**Staff Report & Recommendations (Revised October 12, 2015)**

**Sunrise Terrace Subdivision: Type III**

**Preliminary Plat and SEPA DNS**

(2014-006-SUB) October 5, 2015

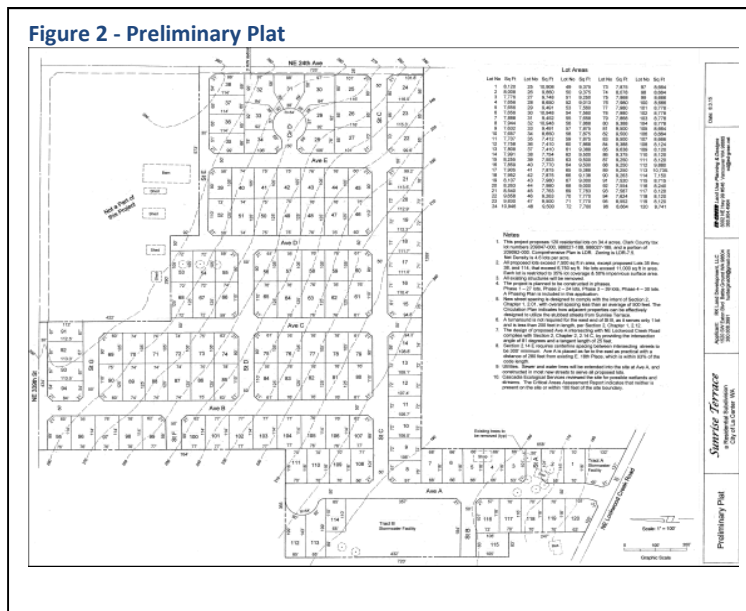
The applicant proposes to subdivide 34.4 acres into 120 residential lots for detached single-family homes. All lots exceed 7,500 square feet in area, except Lots 35 through 38, and Lot 114. (Figure 2.) Net density of the phased project is 4.6 lots per acre. The project will develop in four (4) phases, Phase 1 will take access from NE Lockwood Creek Road. (Figure 3.)

Figure 3 - Sunrise Terrace Phasing Plan

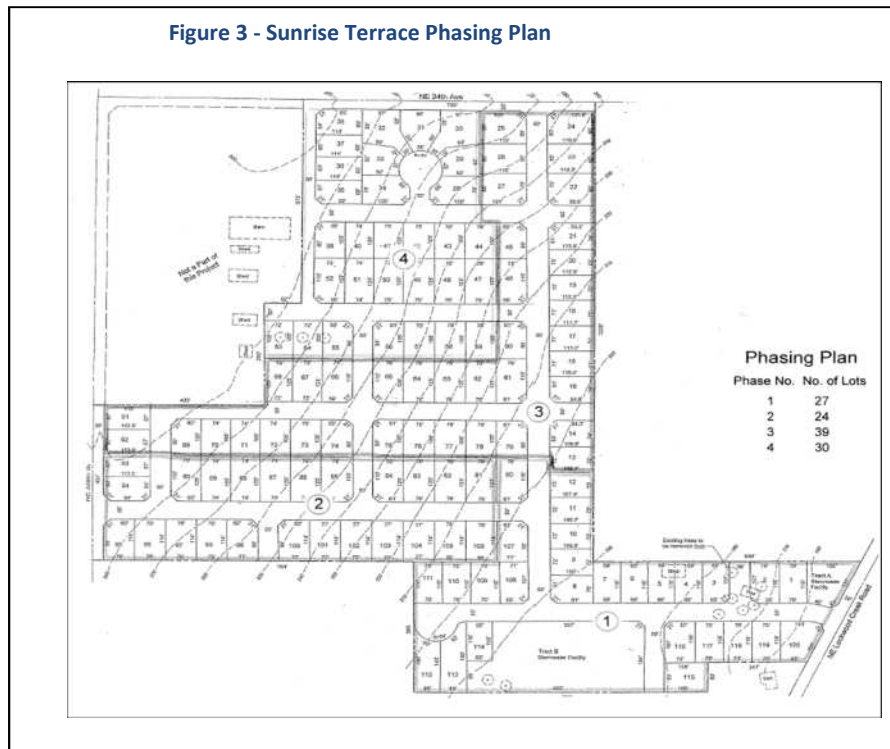
Sunrise Terrace is divided into four phase. (See Figure 3 of this report.) Phase 1 will accommodate the stormwater facilities (Tract A and Tract B) for the entire development. Parks are not required and the proposal does not impact critical areas, however for each phase of the project, the builders shall pay PIFs in effect at the time of building permit application. The preliminary sanitary sewer and potable water system ensures that adequate public facilities and services are available for each phase of the development. Public right-of-way shall be dedicated and public streets and frontage improvements shall be installed at each phase of the development proportionate to the subdivisions impacts and to the extent necessary to ensure adequate circulation and mobility consistent with the City's level of service standards. Therefore, staff concludes that *each phase will provide required public and/or private infrastructure proportionate to the number of lots in each phase; the sequence and timing of phases maintains compliance with applicable standards throughout the development; and the application as proposed and as conditioned assures completion of public improvements consistent with LCMC 18.210.090.*
